PLANNING COMMISSION MEETING AGENDA REGULAR MEETING

February 12, 2013

5. CONDITIONAL REZONING APPLICATION (File Number CR 008) – Proposed Tim Horton's Café, Northwest Corner Square Lake and Dequindre, Section 1, From NN (Neighborhood Node "N") to CB (Community Business) District

Conditional Rezoning, Special Use Permit and Preliminary Site Plan Review For City of Troy, Michigan

SHEET: 01

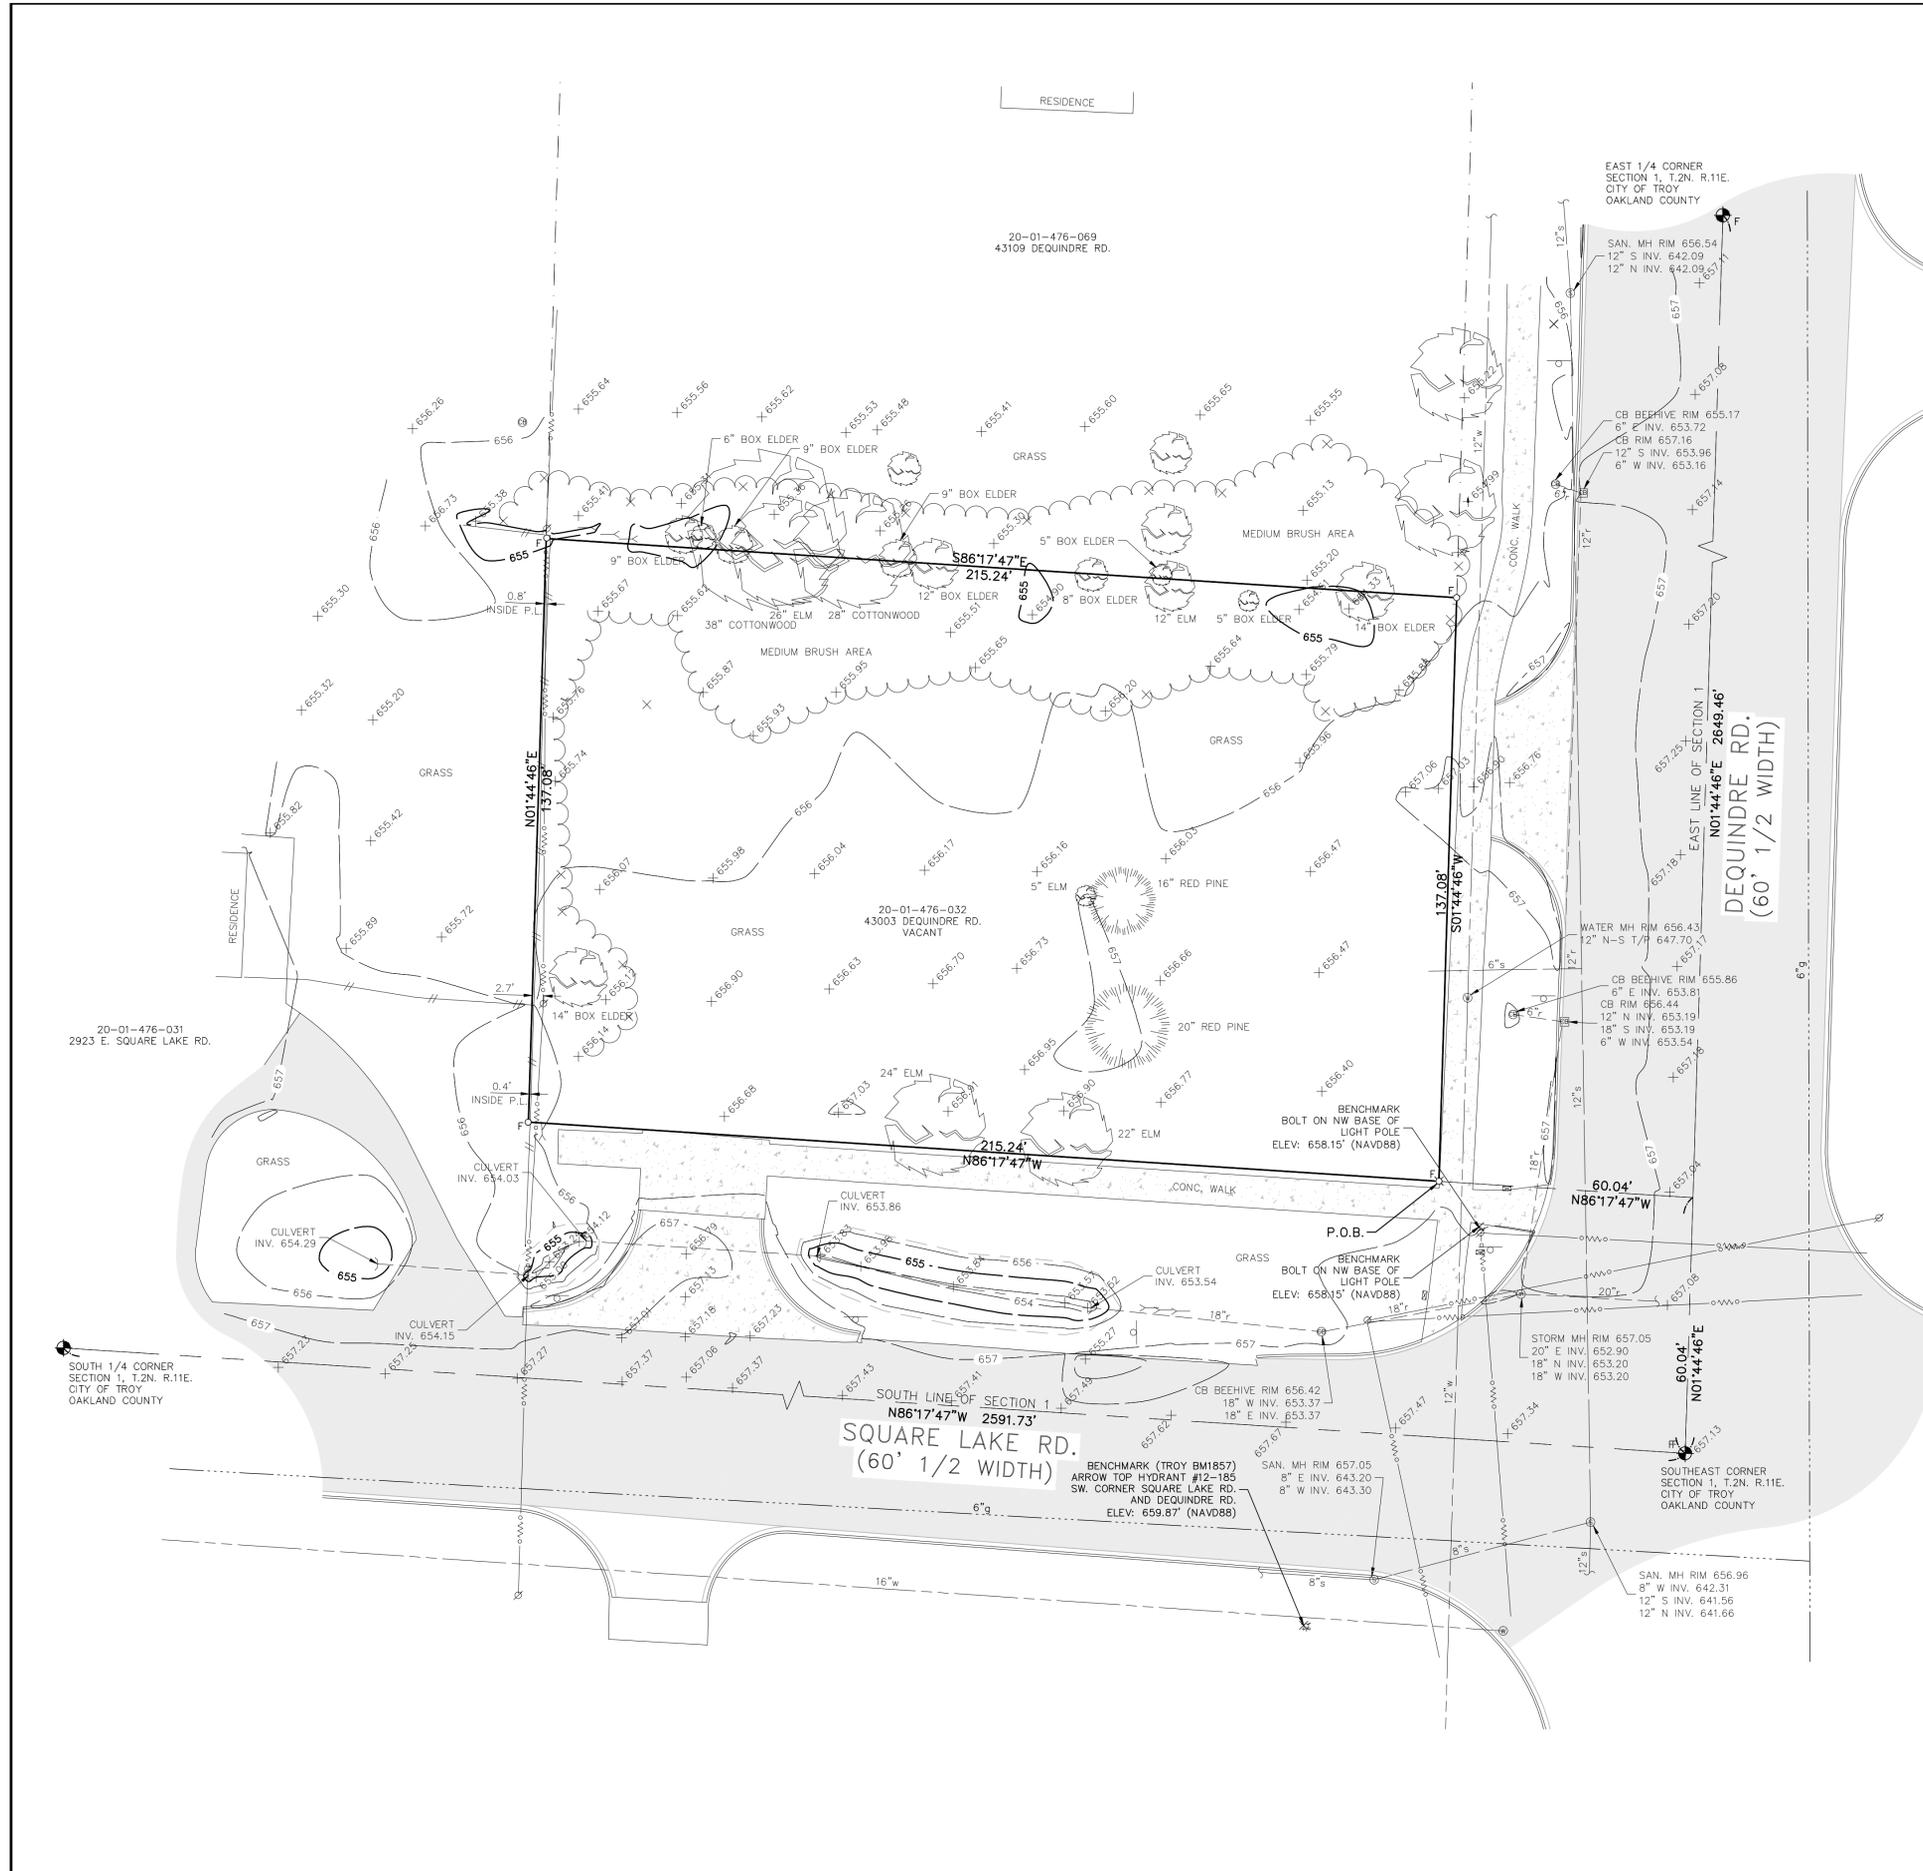
Access to the site will be via a curb cut off Square Lake and a curb cut off Dequindre. The Engineering Department notes that both approaches are irregularly shaped. The applicant should try to reconfigure the approaches so that they enter the property perpendicular to the property line and then provide the necessary radii to match up to the parking lot. This would result in a more typical parking lot layout.

Items to be Addressed: 1). Provide traffic study prior to Planning Commission recommendation of Conditional Rezoning and Preliminary Site Plan approval; 2). Reconfigure the approaches so that they enter the property perpendicular to the property line; 3). Reduce drive-through width to 10 feet; and 4). Reconfigure layout so that the tenth required stacking space does not protrude into drive-aisle.

The applicant is deficient by eight (8) parking spaces. The Planning Commission may reduce the required parking provided that the applicant provide evidence that such parking is not necessary. The approved Maple Road Tim Hortons was exactly the same square footage and provided 22 spaces.

Items to be Addressed: Provide 8 additional spaces, or provide evidence that providing only 18 spaces is sufficient to address site parking needs.

K:\2012\1037_JOB_FOLDERS\1037-12-5504\Drawings\Plan Sets\Conditional Rezoning\1037-12-5504-03-LA.dwg: 10/22/2012 3:38 PM: cshene

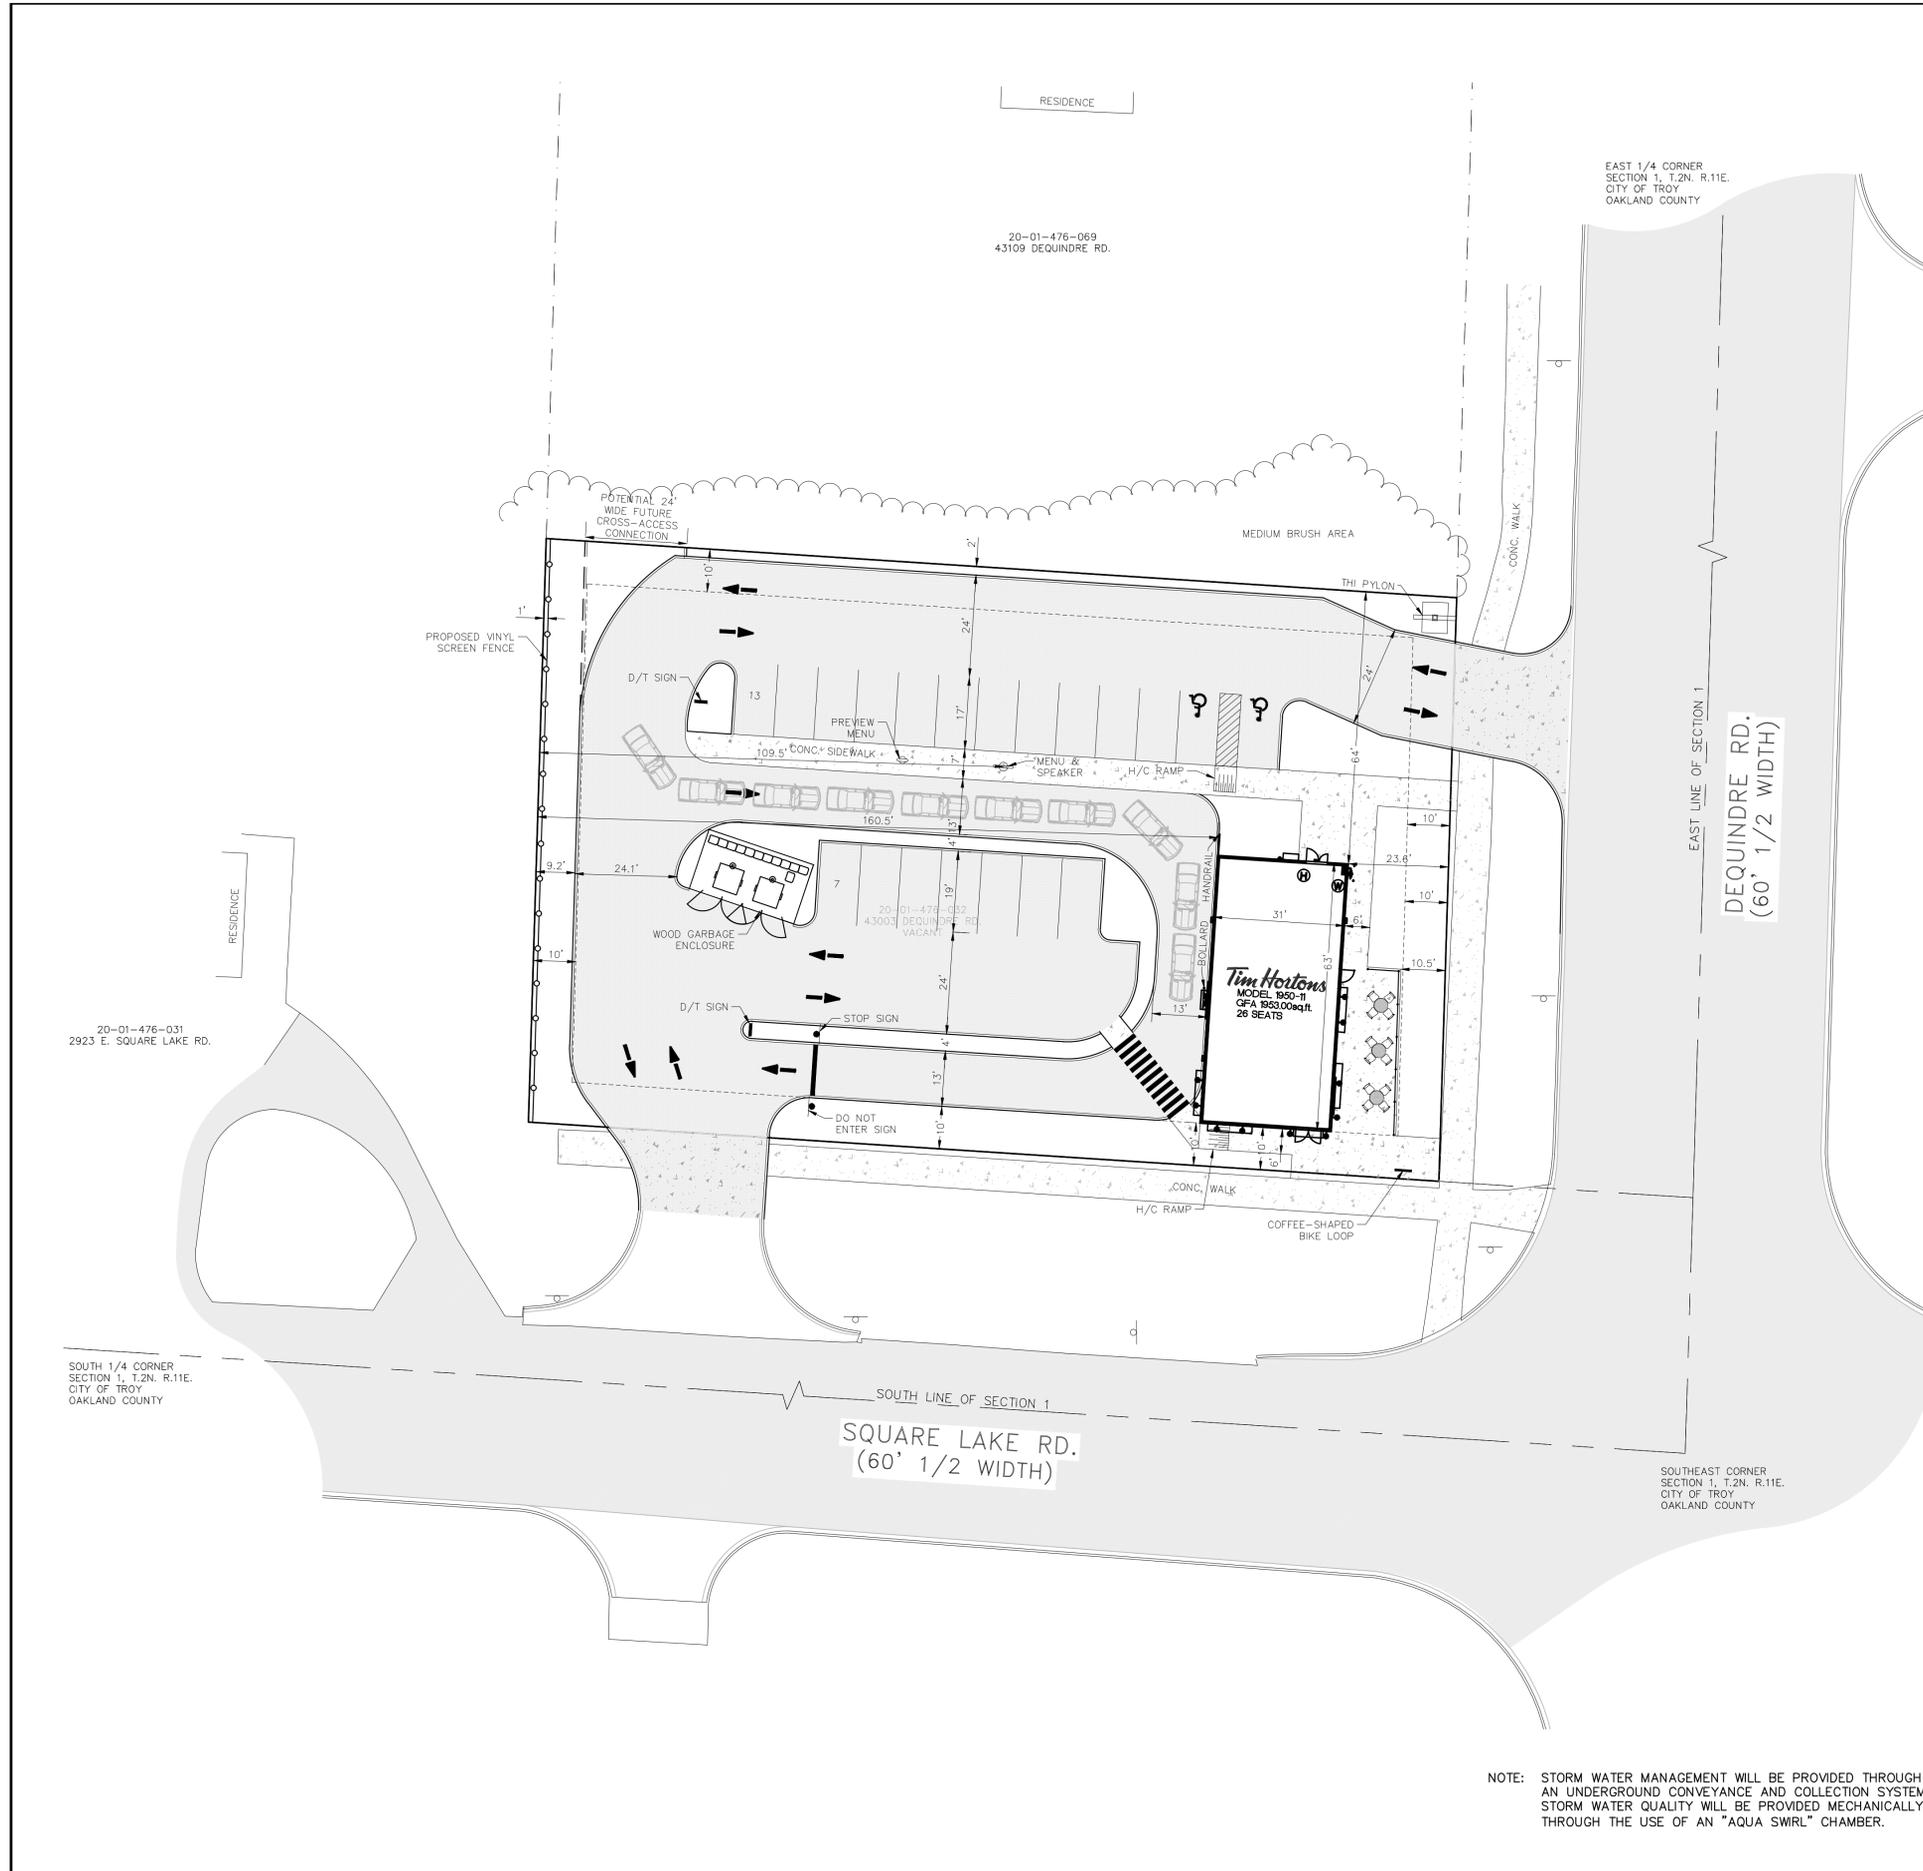
| | <u>Required:</u> | <u>Provided:</u> | <u>Compliance:</u> |
|--|--|--|---|
| <u>Street Trees:</u> The Ordinance requires that the greenbelt shall be landscaped with a minimum of one (1) deciduous tree for every thirty (30) lineal feet, or fraction thereof, of frontage abutting a public road right-of-way. | Square Lake: 8 deciduous Dequindre: 5 deciduous | Square Lake: 5 deciduous and 3 ornamental Dequindre: 5 street trees | Replace ornamental trees with deciduous |
| <u>Parking Lot Landscaping:</u> 1 tree for every 8 parking spaces. Trees may be located adjacent to parking lot with planning commission approval. | 4 trees | 3 trees | Provide one additional tree |

Based on a 0.68 acre site, the applicant is required to provide 592 sq/ft of landscaped area. The applicant should confirm if they have met this requirement. The applicant should indicate on site plan where snow storage is proposed. Lastly, the applicant should provide trash enclosure details; the applicant is encouraged to match the enclosure materials with the masonry of the building.

Items to be Addressed: 1.) Provide overall landscaping calculation; 2.) Replace ornamental trees with deciduous ones along Square Lake; and 3.) Provide one (1) additional parking lot tree; 4.) Indicate on-site snow storage; and 5.) Provide trash enclosure detail.
